PLAN & PROFILE
MONTE VISTA DRIVE
TRACT 2373

PLAN & PROFILE
CHAPALA DRIVE
TRACT 2373

APPROVED BY: <i>[Signature]</i>	J. F. DAVIDSON, CIVIL ENGINEER	PLAN & PROFILE LOS ALTOS COURT STORM DRAIN TRACT 2373	3 OF 2 SHEETS No. R-592
DATE: 11/8/62	3426 TENTH STREET RIVERSIDE, CALIFORNIA		
APPROVED BY:	SCALE: HORIZ. 1"=4' VERT. 1"=4'	BENCH MARK: CITY 3.00 S.E. 1/4 of Sec. 4 of Chicago Ave 100' E. from N.E. corner of Chicago Ave & South St. E.L. 384.31	
DATE:	DATE DEC. 1960	W.O. 10313 FOR: SUN G.O.D., INC.	F.B. 716-1

PLAN & PROFILE
LE CONTE DRIVE
TRACT 2373
 OF 2 SHEETS

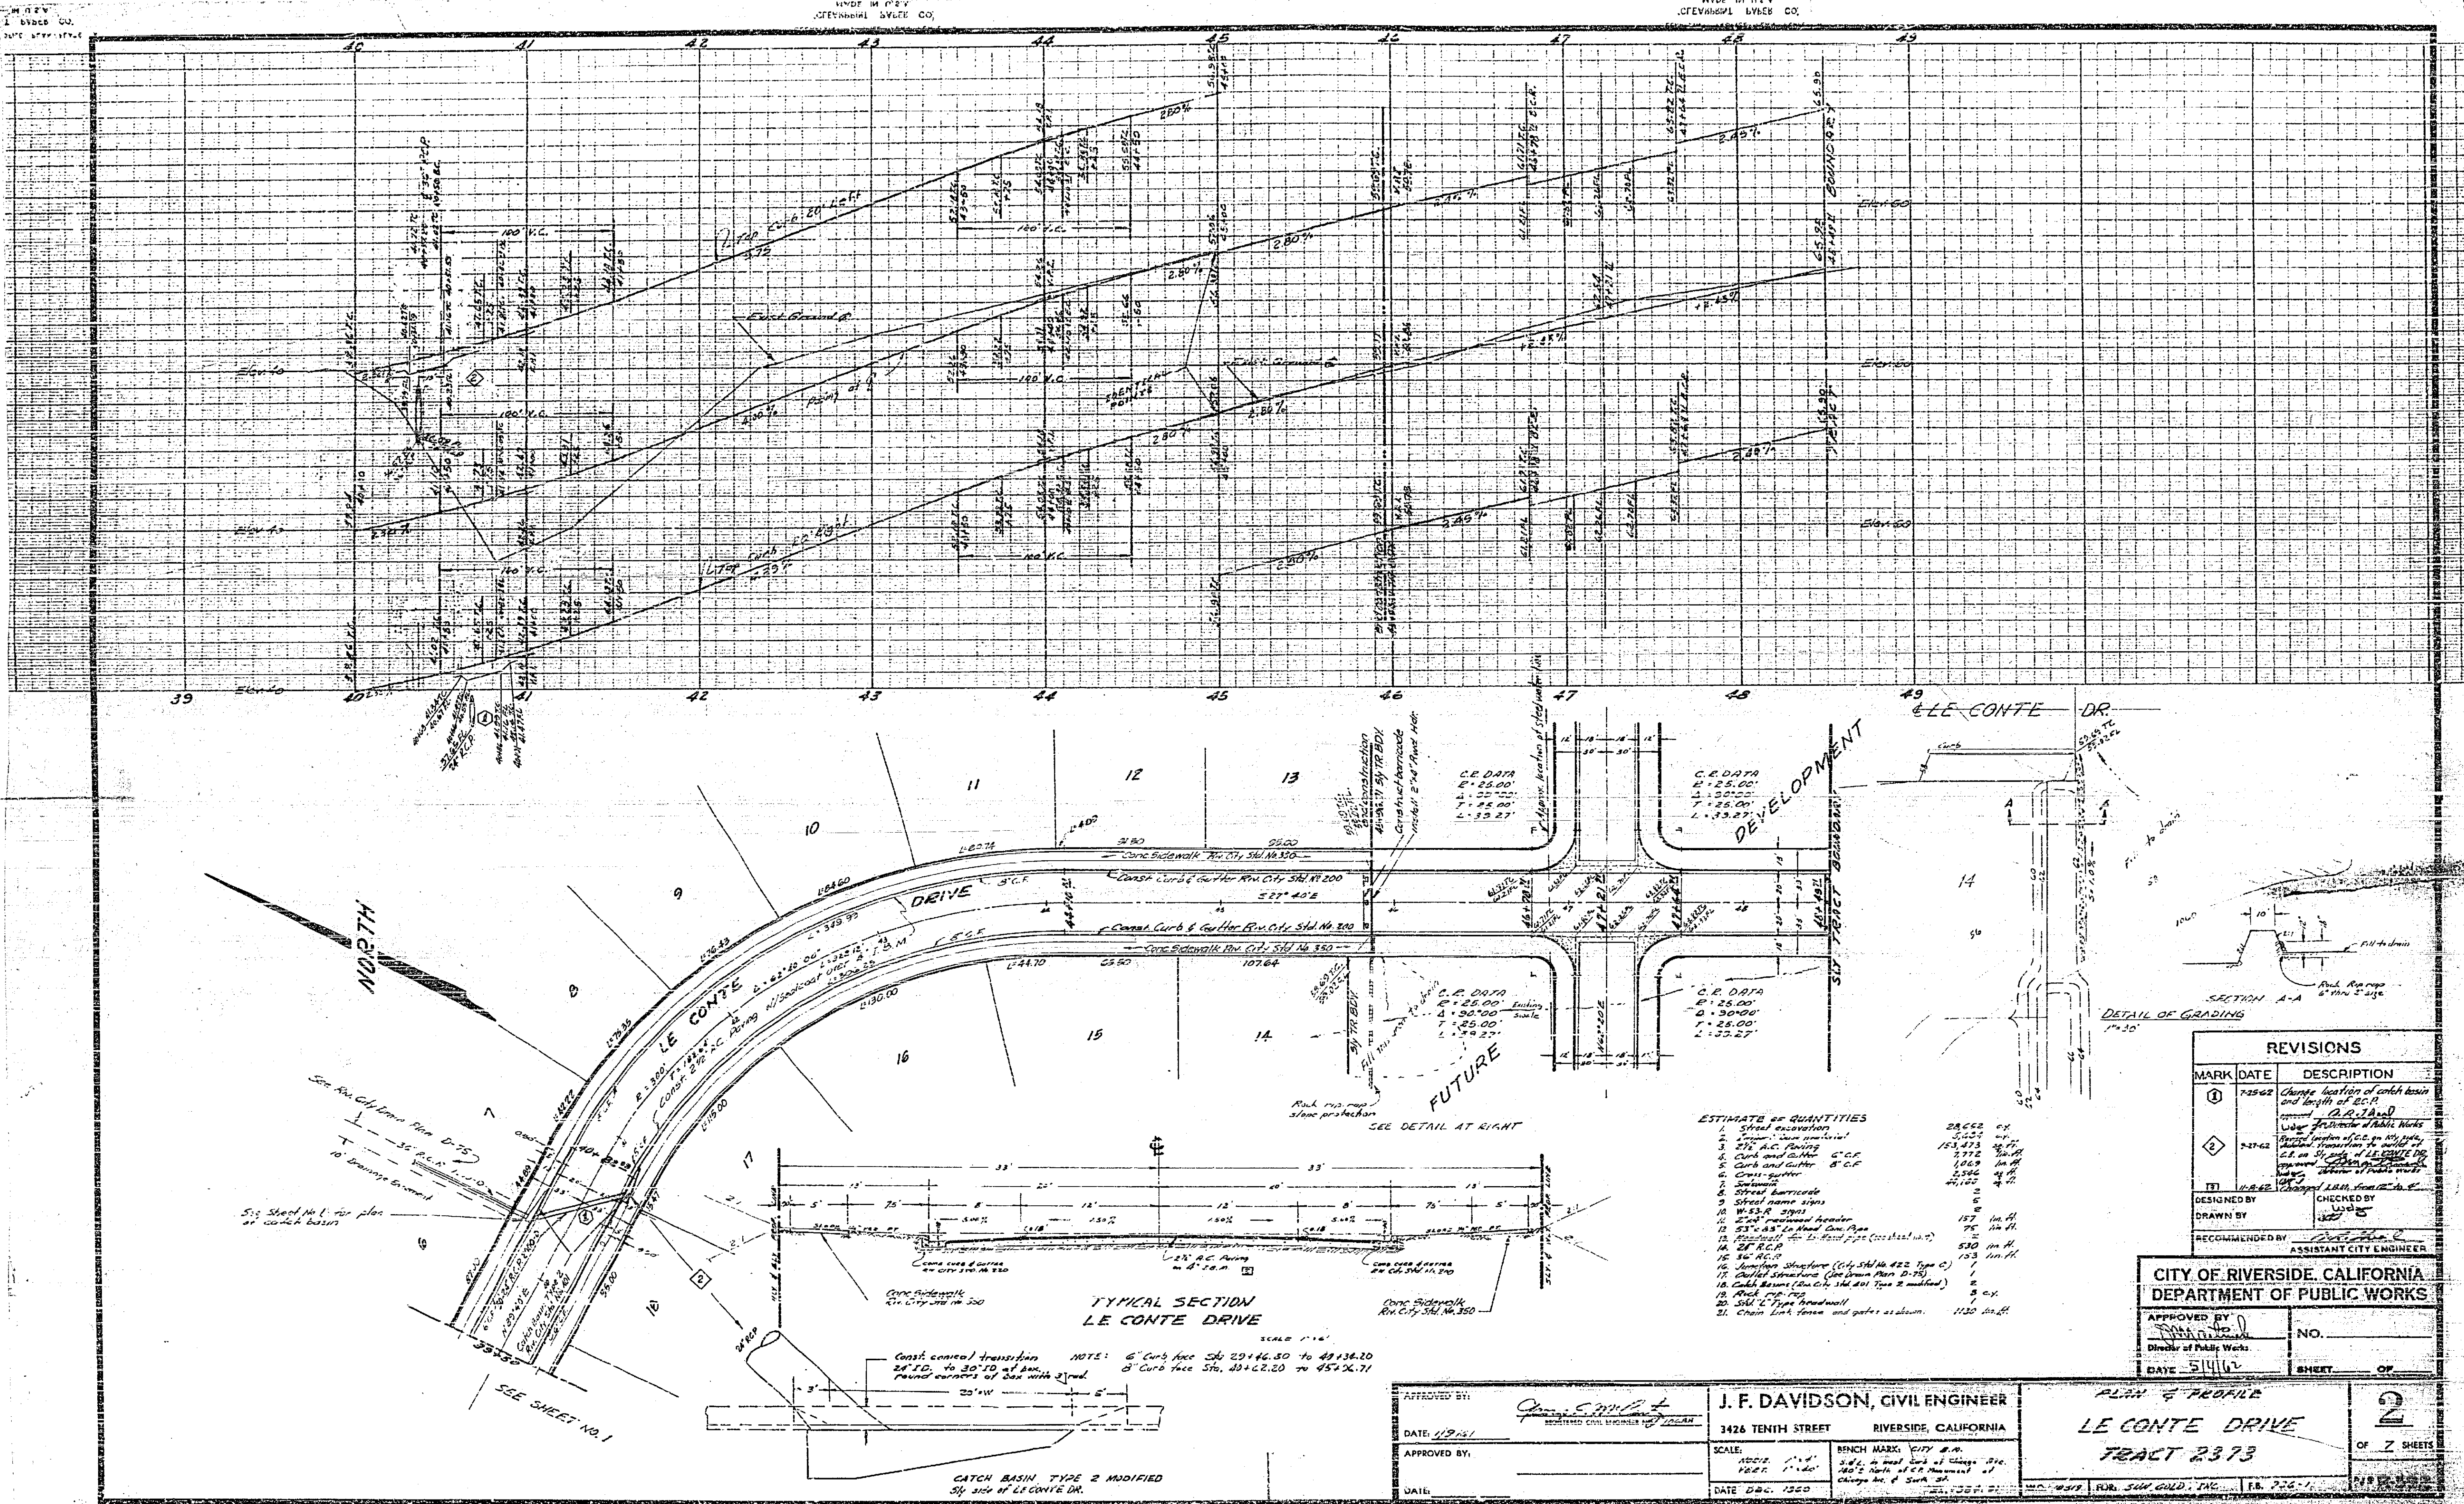
MARK	DATE	DESCRIPTION
①	7-25-62	Change location of catch basin and length of B.C.P.
②	8-27-62	Change location of public works catch basin to suit of C.R. on Sluice Box Alley. Change location of public works catch basin to suit of C.R. on Sluice Box Alley.
③	11-8-62	Changed L.R.M. from 12" to 18"
